## **Bentsen-Rio Grande Valley State Park and Impacts of the Proposed Border Wall**

The Texas Parks and Wildlife Department (TPWD) attended a meeting with U.S. Customs and Border Protection (CBP) on June 7, 2018 at Bentsen-Rio Grande Valley State Park (BRGVSP). During this meeting CBP shared the conceptual design of the border wall planned for construction through and adjacent to BRGVSP. At CBP's request, TPWD has prepared this statement outlining the adverse impacts of the border wall on BRGVSP, along with alternatives to alter or modify the design in order to lessen adverse impacts to park resources and visitor experiences. TPWD desires to work with CBP on implementing a range of enforcement strategies, while preserving the viability of BRGVSP as wildlife habitat and a visitor destination.

**World Birding Center at Bentsen Rio Grande Valley State Park  
- Homeland Security Border Wall Schematic Interpretation**

*View of park headquarters from levee*

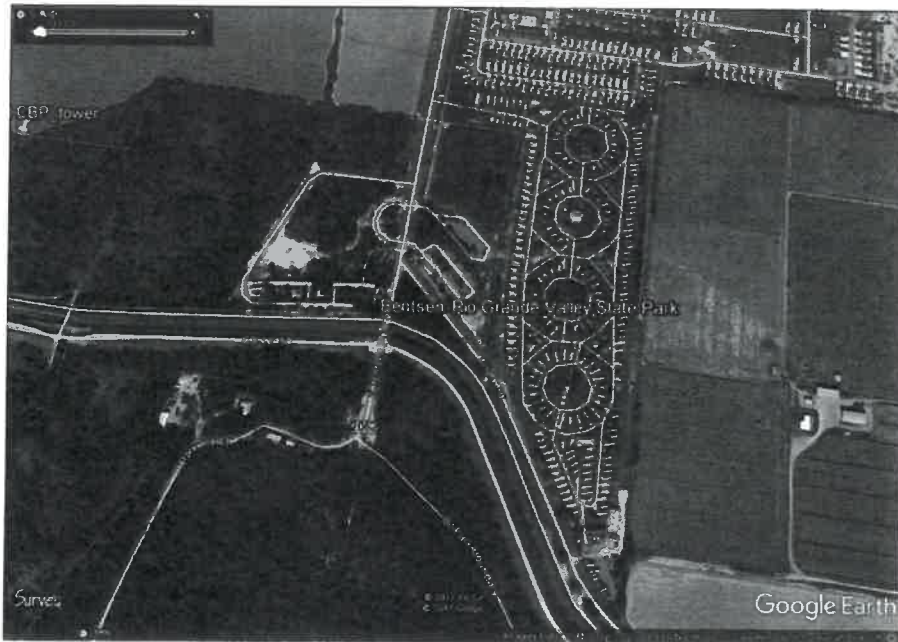
Initial proposals for the alignment of the border security wall would have substantial impacts on the operations and public access to the park. Proposed placement of the wall would essentially separate the park's Headquarters, Visitor and Education Center from the great majority of park property, including staff residences and other facilities, which would be located behind the Border Wall. The entire habitat preserve would be south of the wall, creating a barrier to public access, use, and enjoyment.

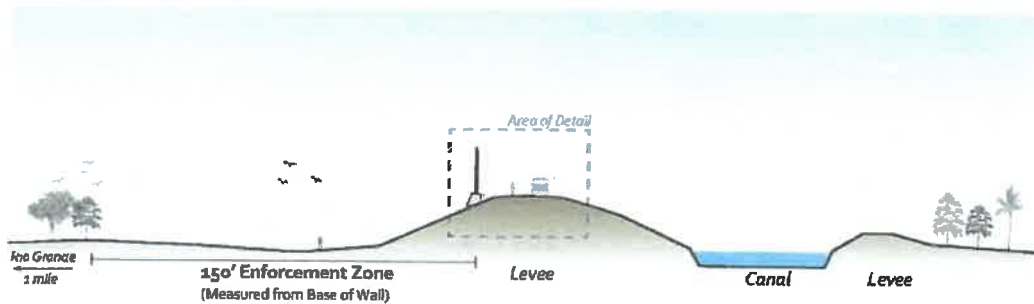
Under the current CBP plan, the alignment of the border security wall would have substantial adverse impacts on the operations and public access to the state park (see attachment). The proposed placement of the wall would separate the state park's Headquarters and Visitor and Education Center from the majority of the park property, including staff residences and other facilities. The entire habitat preserve would be south of the wall, creating a barrier to public access and use.
